00-DOE-00560

Enclosed please find a copy of the Document Change Notice incorporating Wetland Sampling in the Americium Zone for the "Sampling and Analysis Plan for the Site Characterization of the 903 Drum Storage Area, 903 Lip Area, and Americium Zone, RF/RMRS-97-084." Please remove and recycle Pages i/ii and v of the Table of Contents, Figure 1.2 (page 8), 15/16, 41/42, and insert Figure 3.5 as Page 44A of the above noted Sampling and Analysis Plan and replace them with the attached pages. Changes are reflected in the left margin of the affected pages by the 10/25/99 vertical change bar. Sampling is scheduled for the week of November 15, 1999.

Sampling and Analysis Plan for the  
Site Characterization at the  
903 Pad Drum Storage Area, 903 Lip Area  
and Americium Zone

## Wetland Area Radiological Sampling Locations Figure 3.5

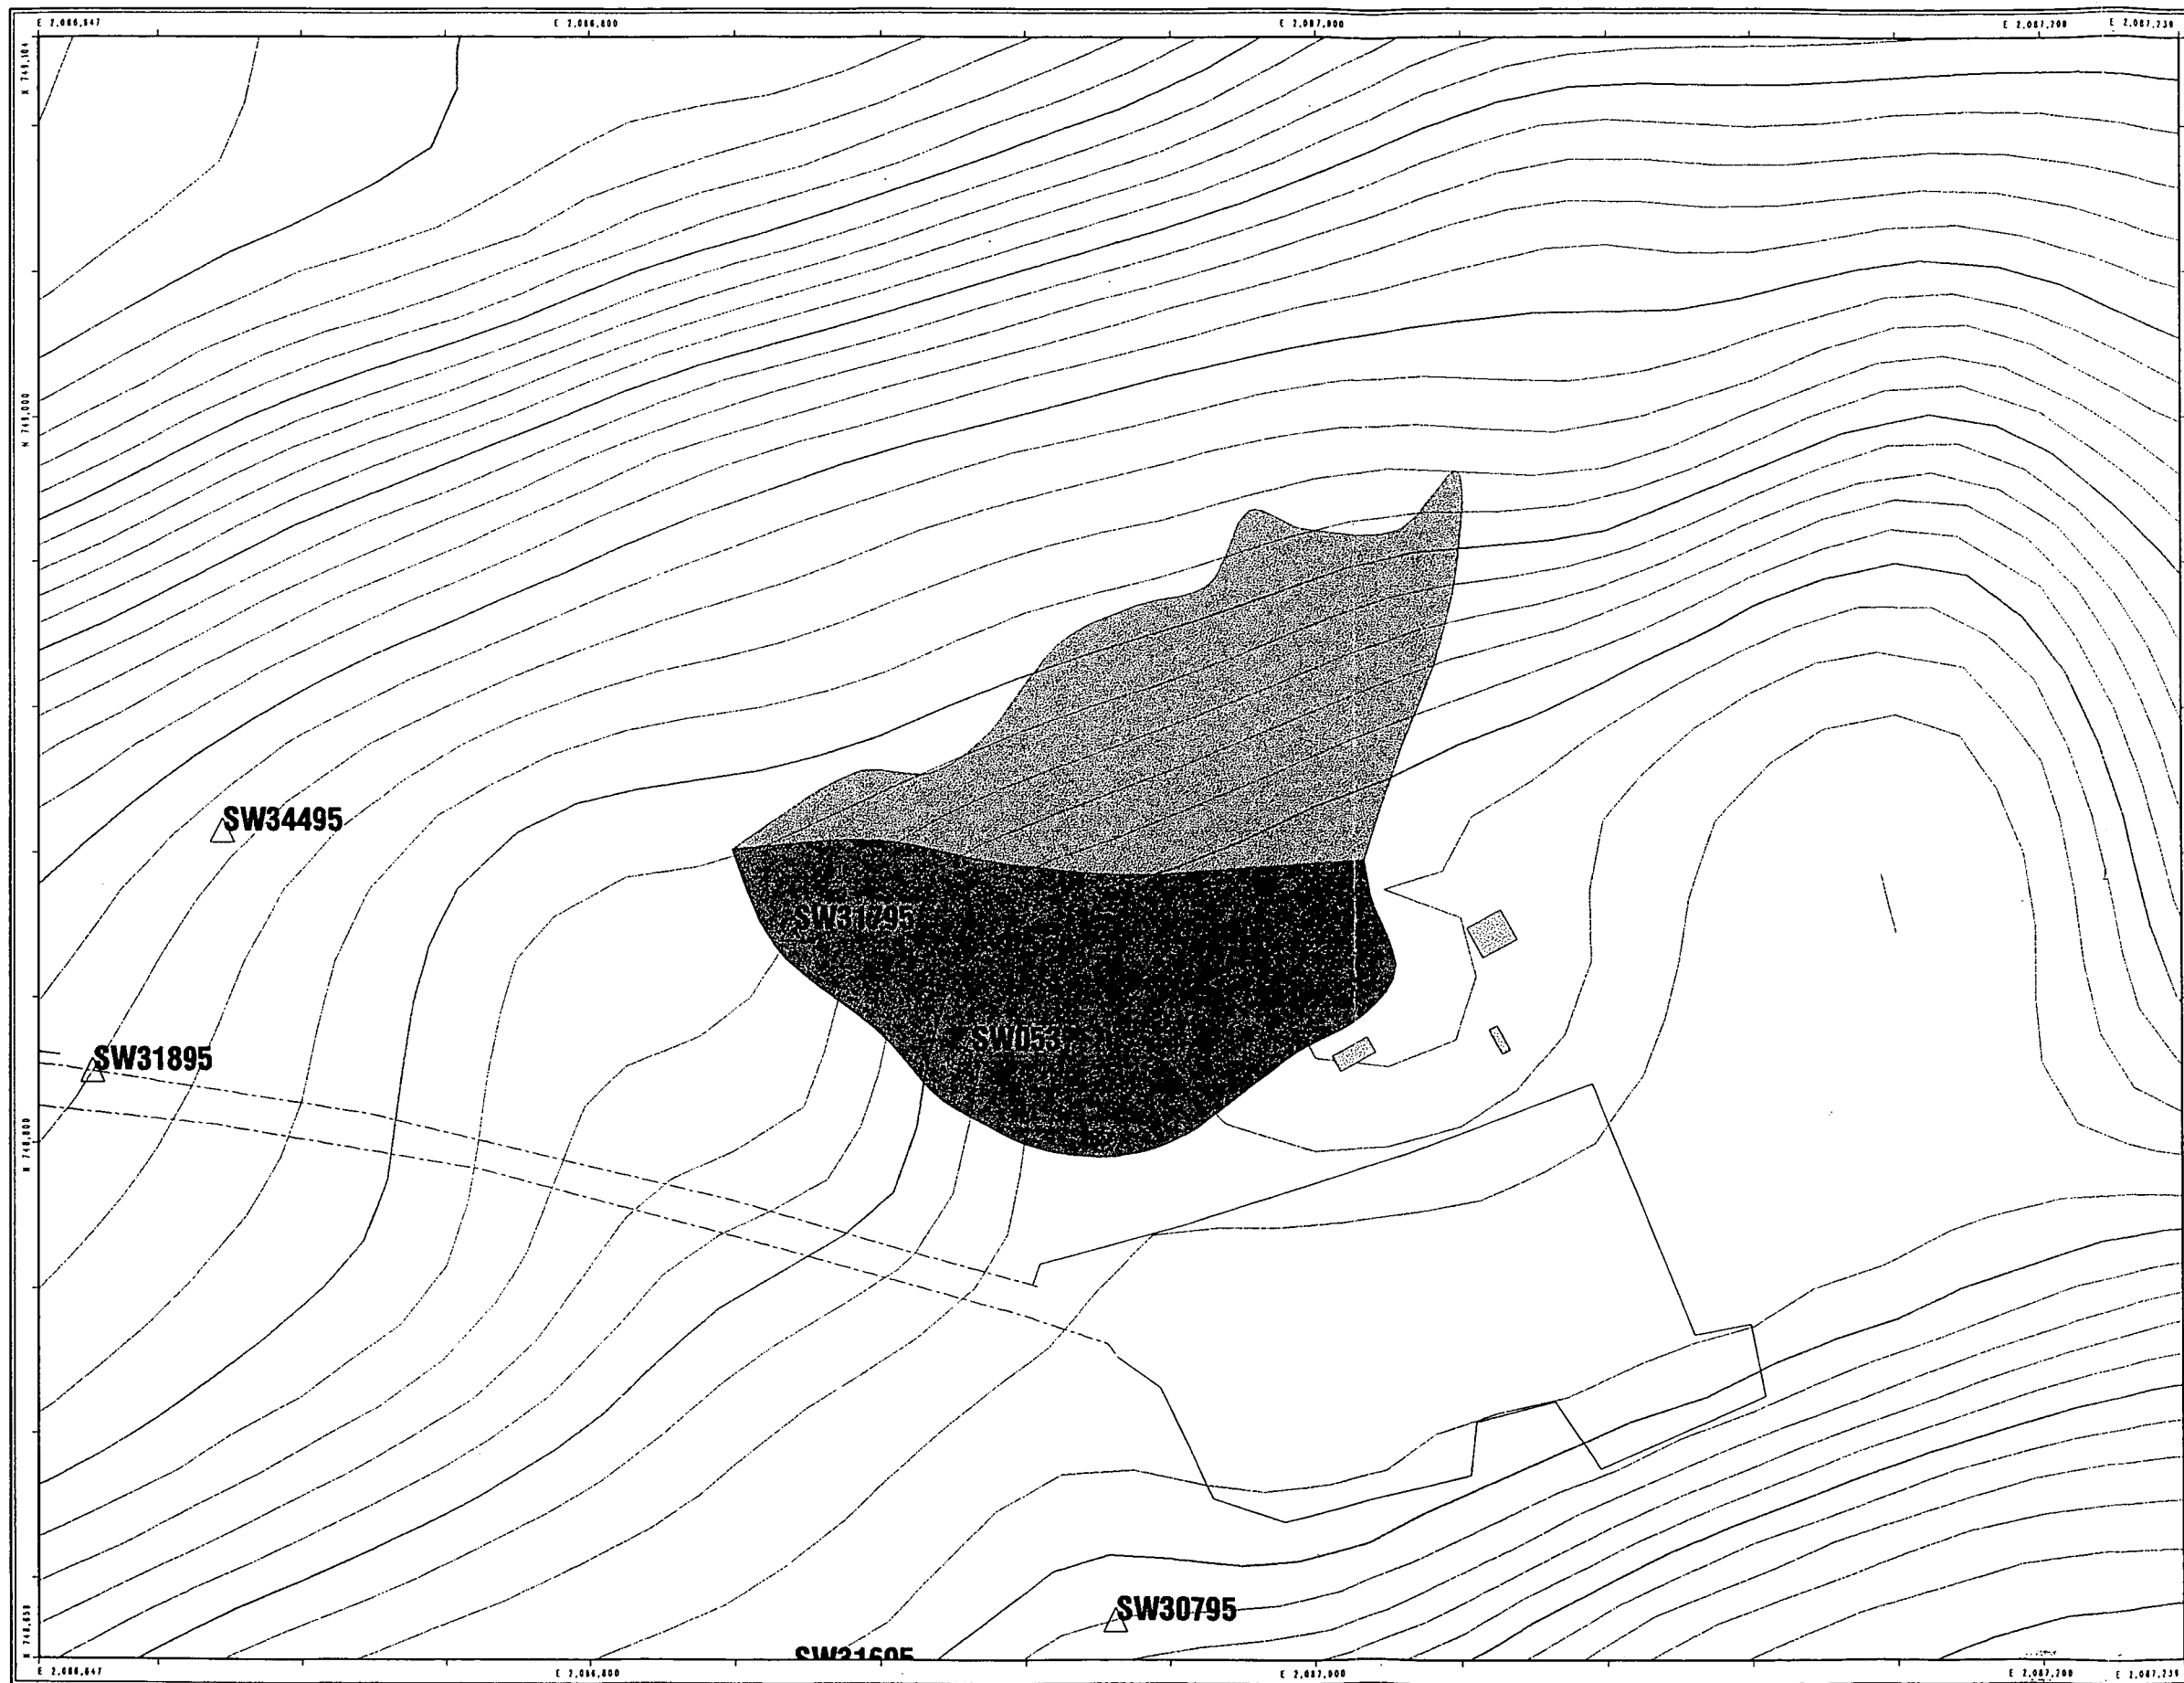
*Americium Zone* – Surface and subsurface soil samples will be collected in the wetland area of the Americium Zone to determine the depth of radiological contamination associated with the surface water radiological exceedances observed in SW053 (Figure 3.5). Soil borings located in the wetland and soil samples will be collected utilizing slide hammer driver corer as described in RMRS/OPS-PRO-.085, Pond and Reservoir Bottom Sediment Sampling. Soils will be continuously cored to a total depth of 0.46 m (1.5 ft). Samples will be collected at approximately 15 cm (6 in) intervals to a depth of 0.31 m (1 ft).
